Conservation Commission
Minutes January 20, 2016 12:30 PM Town Hall
FINAL

Chilmark Conservation Commission Questions
January 12, 2016

Sheet C1
 Parking and Restoration Plan
 Chilmark, Mass.
 Prepared for
The Town of Chilmark
 December 17, 2015 Scale 1" = 30'
 01-19-2016: supplemental information sheet

Response of Squibnocket Farm, Inc. to Chilmark Conservation Commission Questions

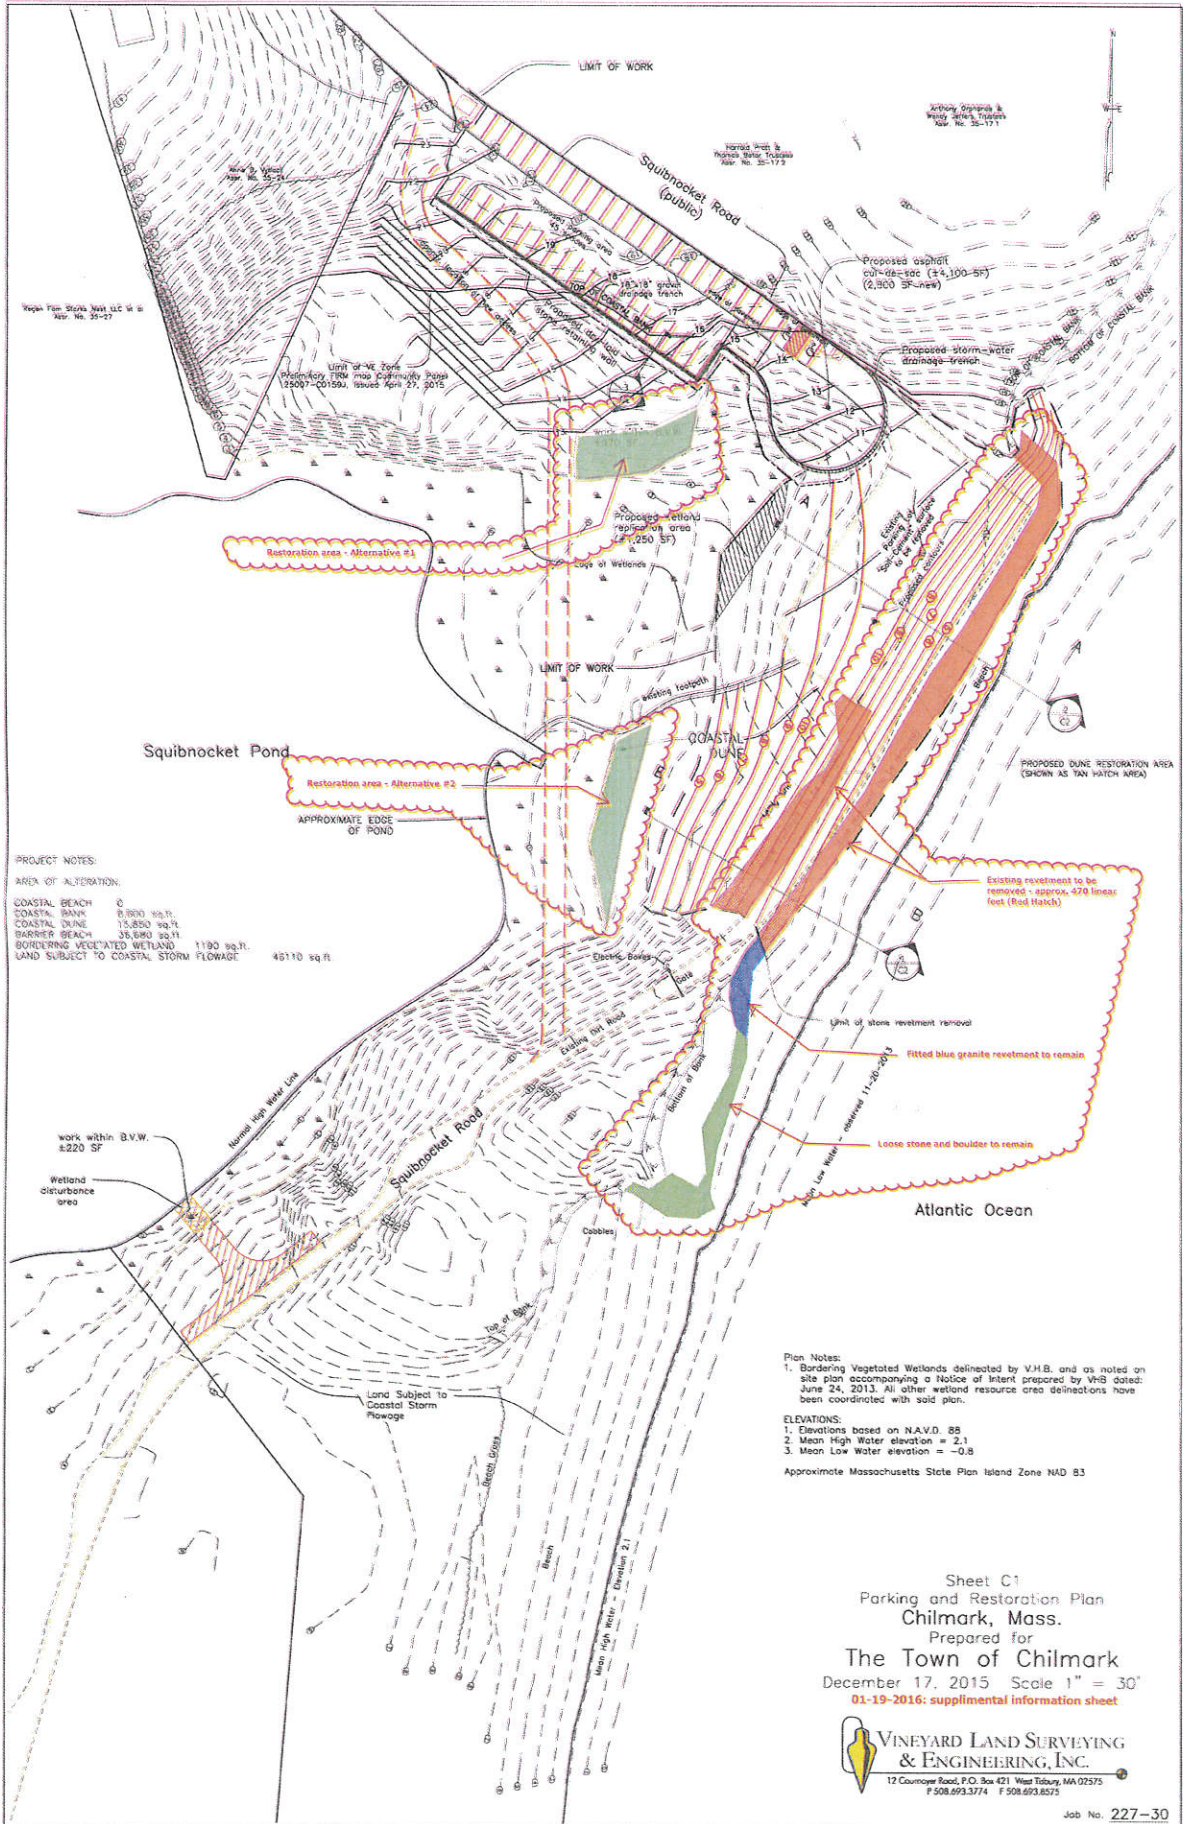
1. How many feet of parking lot revetment are being removed? **Approx. 470 ft.** Once the parking lot revetment is removed, how many feet westward does the remaining revetment extend? **Approx. 35' of blue granite and a total of approx. 140' of stone will remain in place.** Please indicate both the removed and remaining revetment on a map. **See attached plan**

4. Were alternative sites for the replication area considered? If so, which ones and why were they considered inferior? **Yes, alternative sites were considered but were found inferior (see attached sketch). Alt. 1 was rejected due to added disruption to an area outside of the project limits. Alt. 2 was rejected due to the dis-similar wetland types. Most of the displaced wetland borders a freshwater spring adjacent to Squibnocket Road. Alt. 2 is a low lying area adjacent to the pond consisting primarily of marsh grasses and fringe marsh vegetation. The proposed replication area was chosen to limit disturbance to an area within the project boundary and to provide similar wetland species and characteristics to those that are being displaced.**
